**ROCKFORD BOARD OF EDUCATION
INVITATION FOR BID ON SUPPLIES, MATERIALS, EQUIPMENT OR SERVICES
FOR SCHOOL DISTRICT NO. 205
ROCKFORD, ILLINOIS**

IFB No. 22-23 HVAC & Roofing Projects at Lincoln, East, Washington & Flinn Schools

RE: **ADDENDUM NO. 9**

FIRST FLOOR REFLECTED CEILING PLAN - AREA E

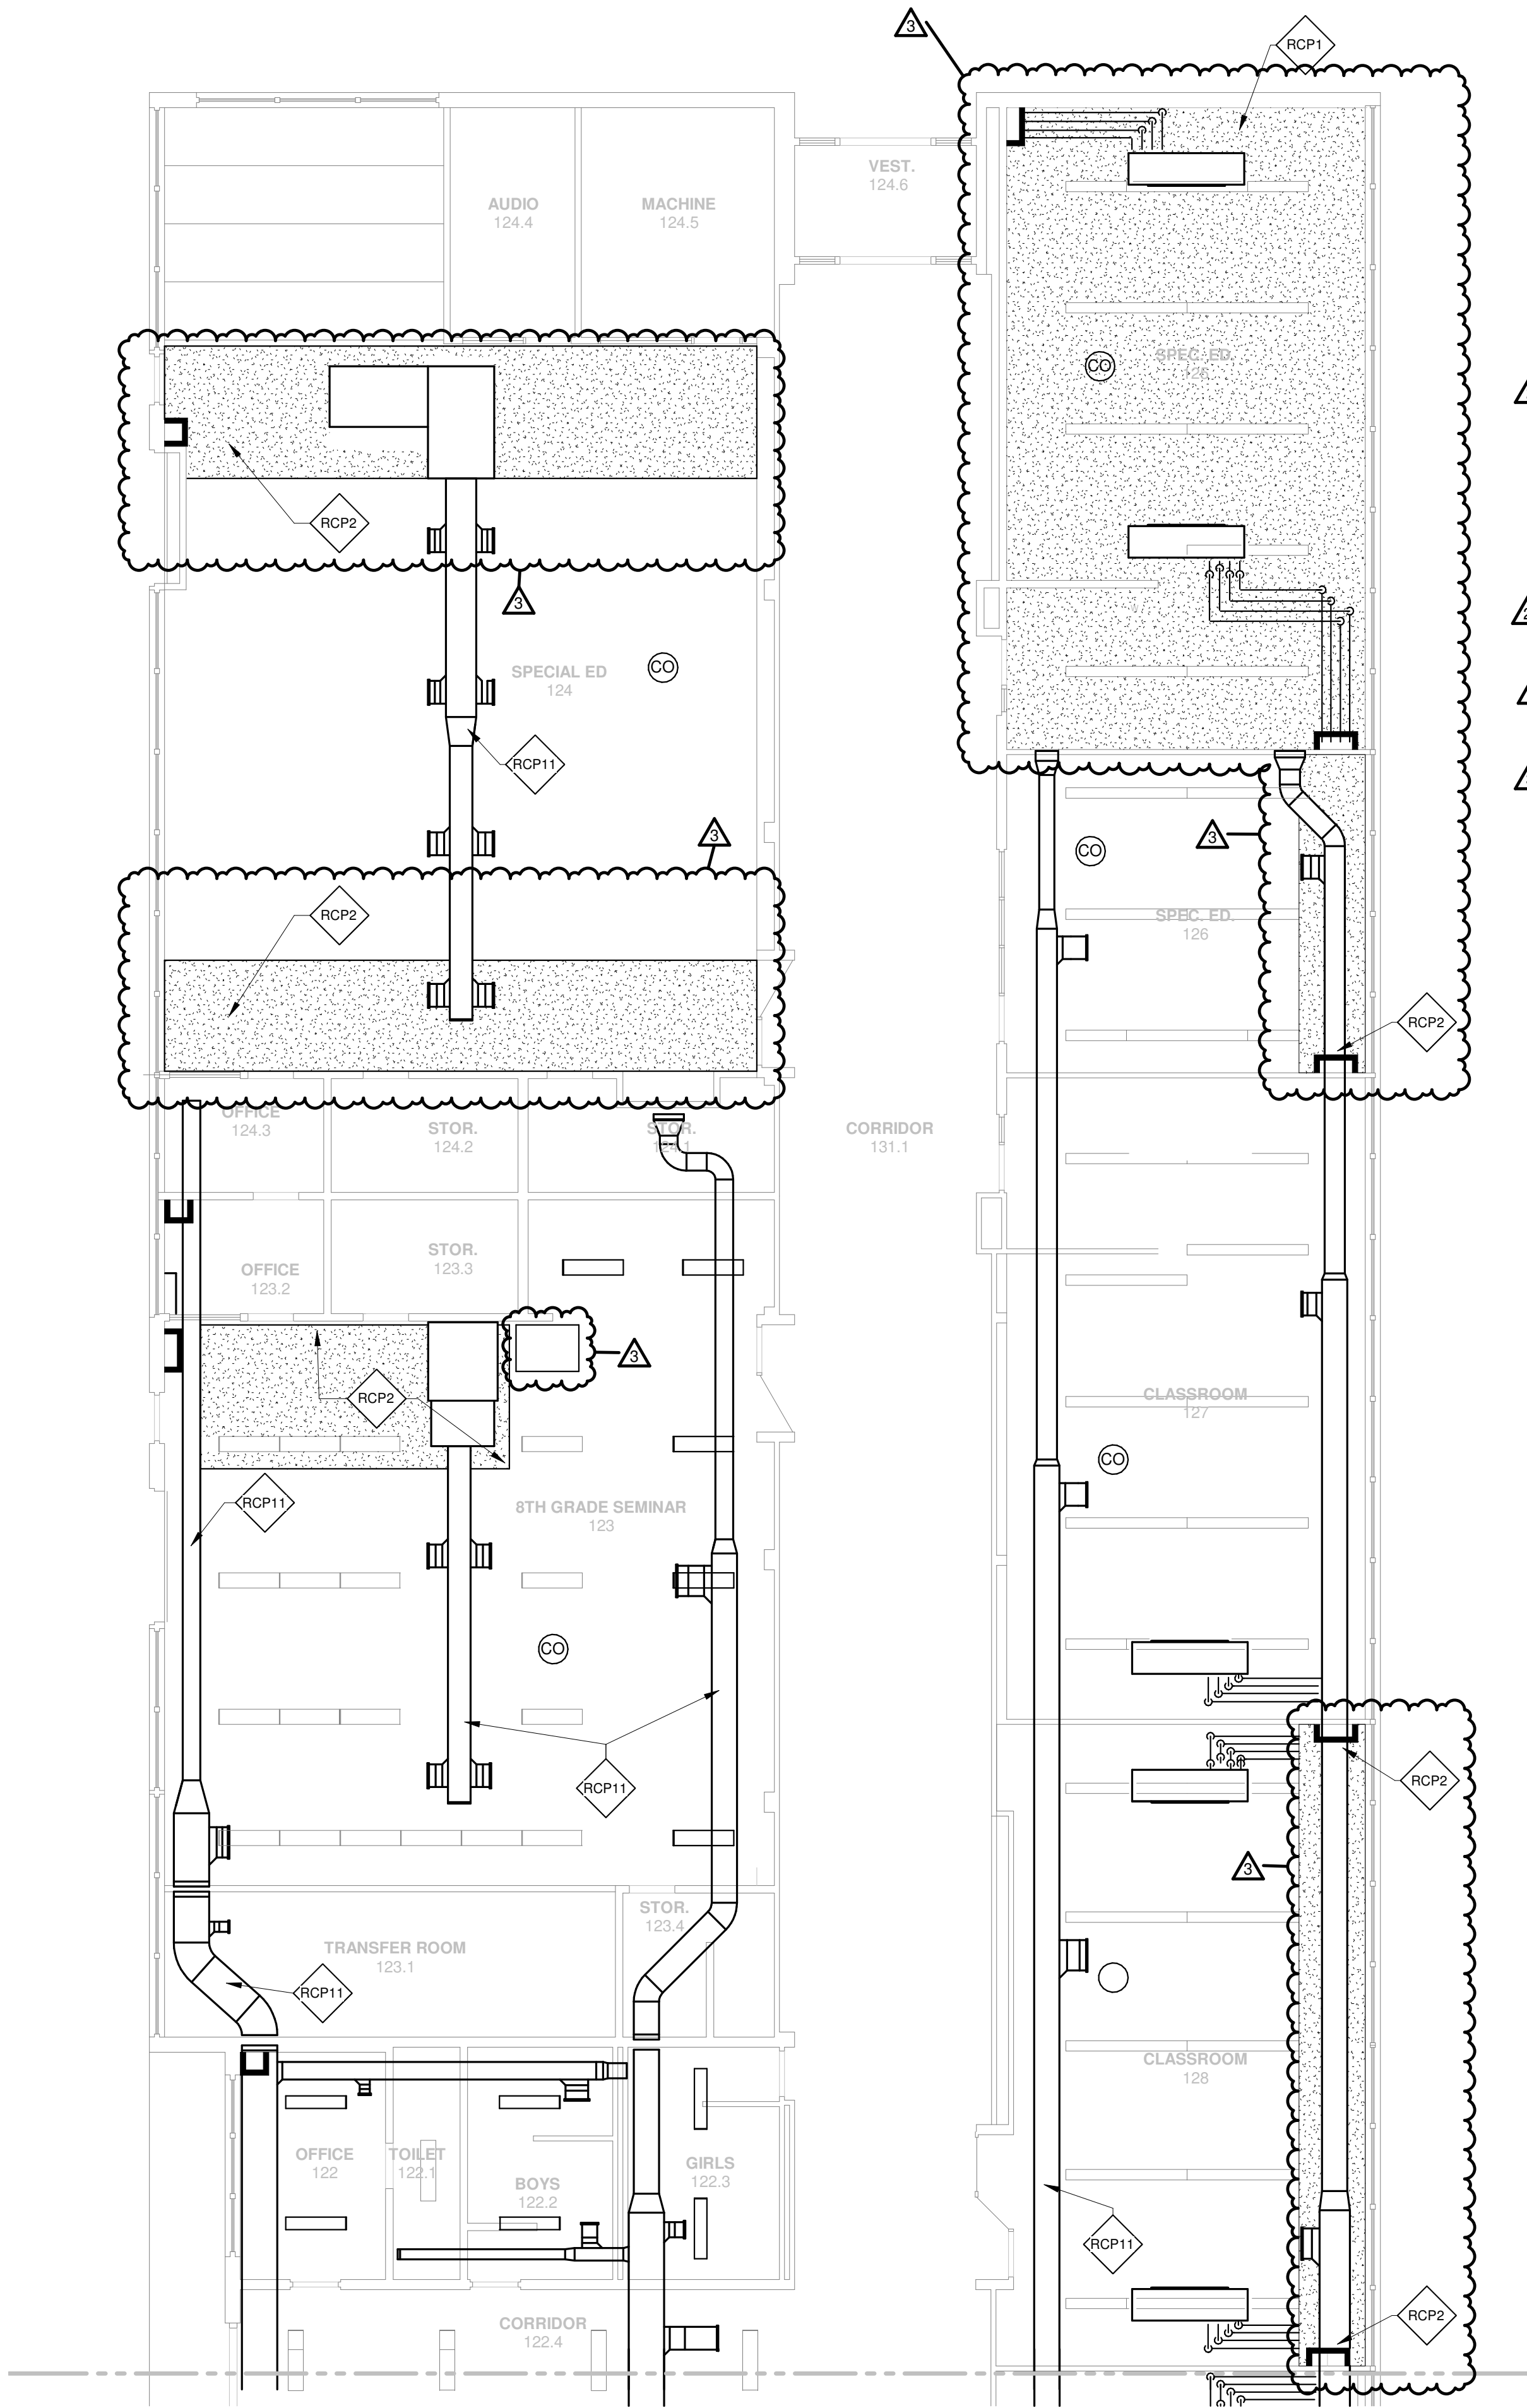
24. DRAWING A2.01E – FIRST FLOOR REFLECTED CEILING PLAN - AREA E **REPLACE** entire sheet A2.01E – FIRST FLOOR REFLECTED CEILING PLAN - AREA E dated 03/10/2022.

- a. **REVISE** note RCP2 "Existing plaster ceiling to be patched, prep and paint with gypsum board system. Provide a clean expansion joint between existing plaster ceiling and new gypsum board. Refer to detail 2/A2.02A", to read as follows "Existing plaster ceiling to be patched, prep and with gypsum board system. Provide a clean expansion joint between existing plaster ceiling and new gypsum board. Provide acoustical ceiling panels. Refer to detail 2/A2.02A".

A2.02B

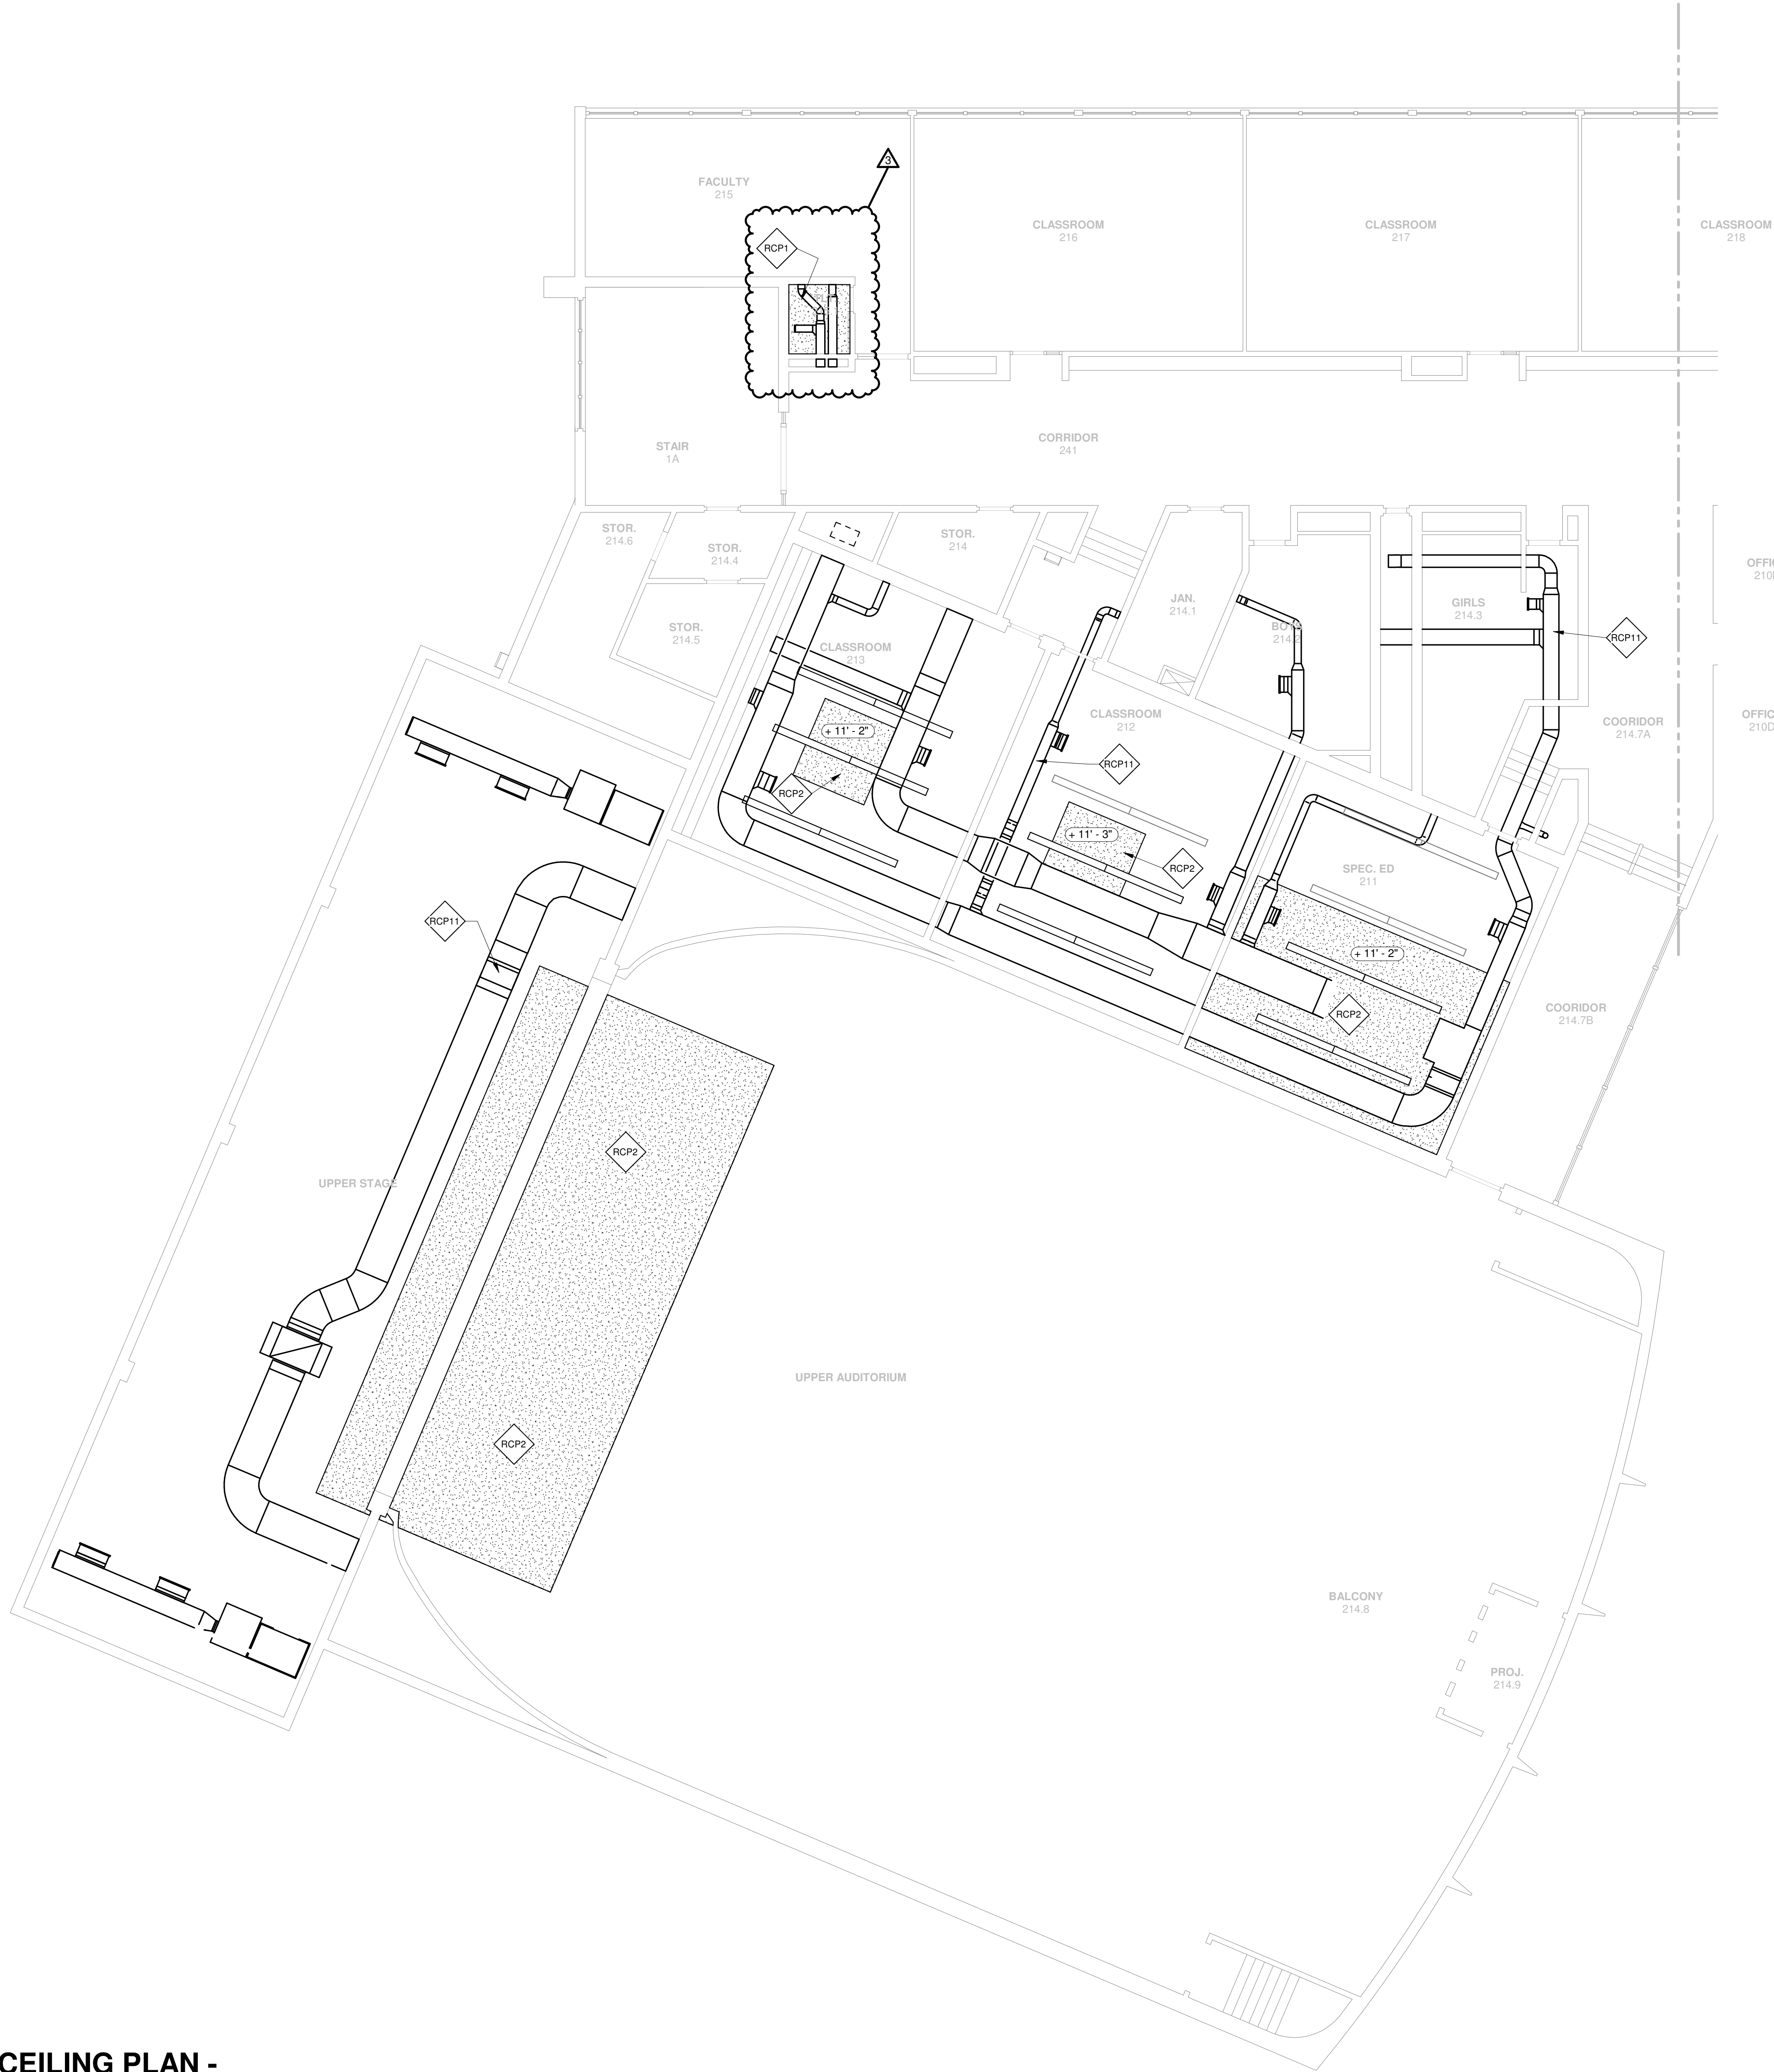
- f. **ADD** note RCP 14 "Paint exposed structure and the new ductwork".
- 26. DRAWING A2.02B – SECOND FLOOR REFLECTED CEILING PLAN - AREA B & C
REPLACE entire sheet A2.01B – SECOND FLOOR REFLECTED CEILING PLAN - AREA B & C dated 03/10/2022.

- a. **REVISE** note RCP2 "Existing plaster ceiling to be patched, prep and paint with gypsum board system. Provide a clean expansion joint between existing plaster ceiling and new gypsum board. Refer to detail 2/A2.02A", to read as follows "Existing plaster ceiling to be patched, prep and with gypsum board system. Provide a clean expansion joint between existing plaster ceiling and new gypsum board. Provide acoustical ceiling panels. Refer to detail 2/A2.02A".

SHEET TITLE
SECOND FLOOR REFLECTED CEILING PLAN - AREA D

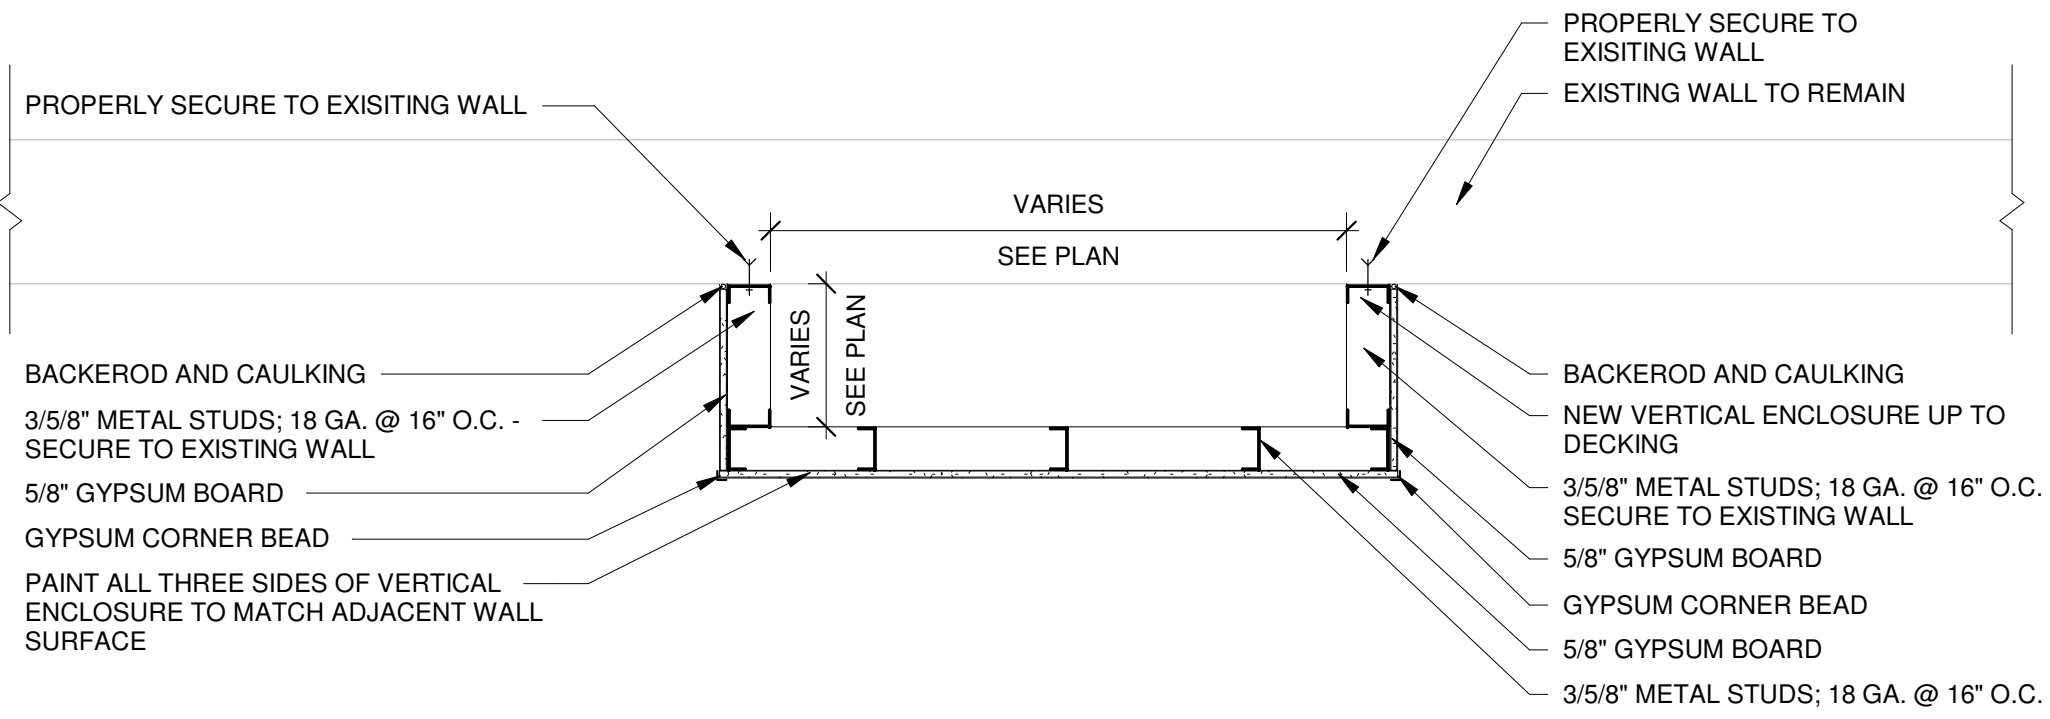
- 27. DRAWING A2.02D – SECOND FLOOR REFLECTED CEILING PLAN - AREA D
REPLACE entire sheet A2.01D – SECOND FLOOR REFLECTED CEILING PLAN - AREA D dated 03/10/2022.

- a. **REVISE** note RCP2 "Existing plaster ceiling to be patched, prep and paint with gypsum board system. Provide a clean expansion joint between existing plaster ceiling and new gypsum board. Refer to detail 2/A2.02A", to read as follows "Existing plaster ceiling to be patched, prep and with gypsum board system. Provide a clean expansion joint between existing plaster ceiling and new gypsum board. Provide acoustical ceiling panesl. Refer to detail 2/A2.02A".

4 A TYPICAL DETAIL AT ACCESS DOOR

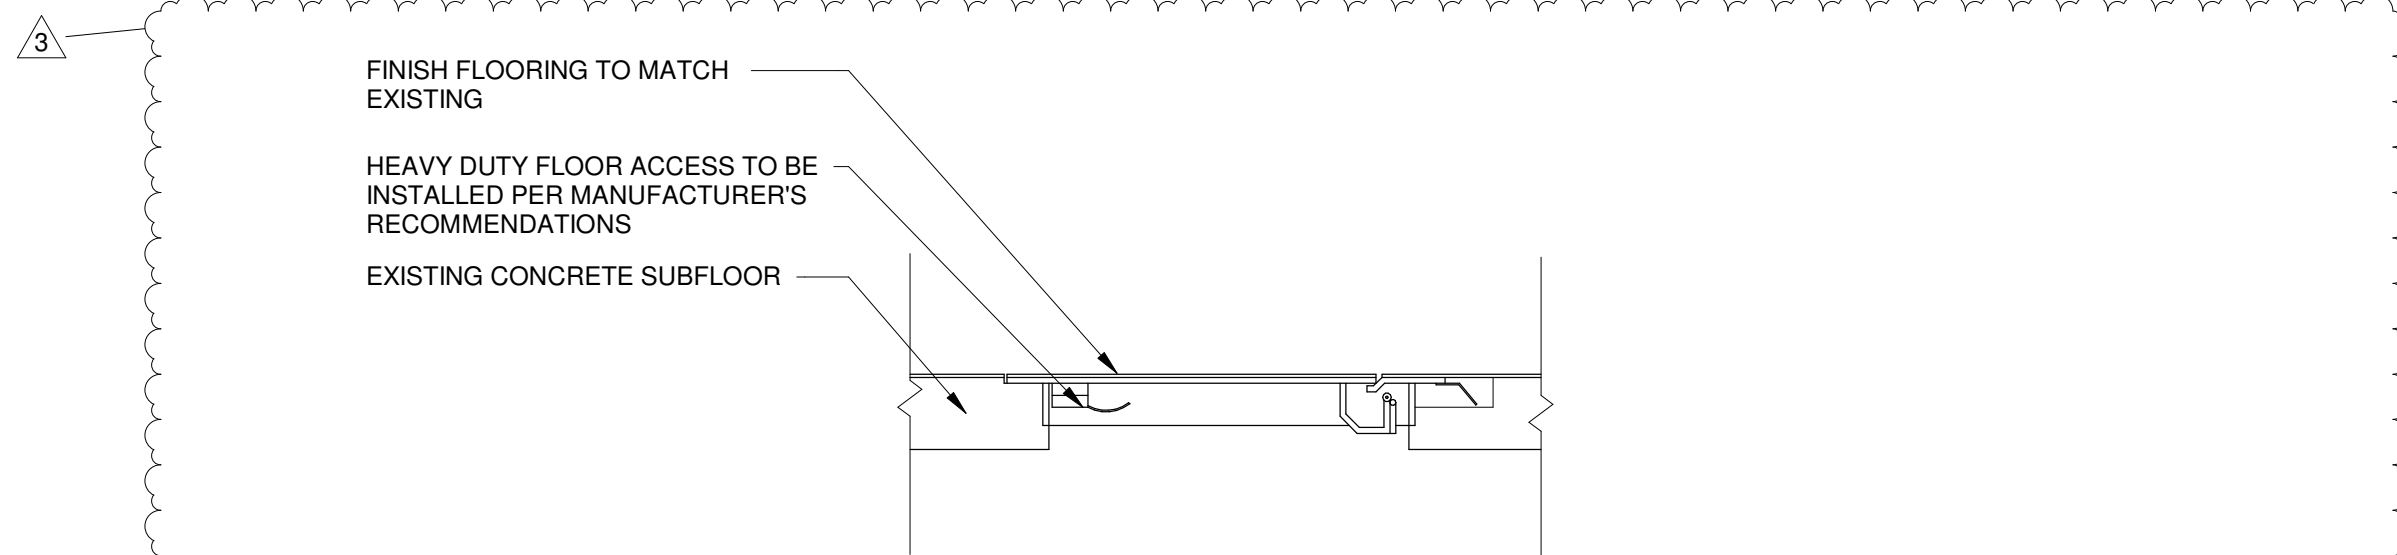
- 28. DRAWING A4.00 – DETAILS **REPLACE** entire sheet A4.00 – DETAILS dated 03/10/2022.
 - a. **REVISE** detail "4/A4.00" to read as follows, "4A/A4.00"
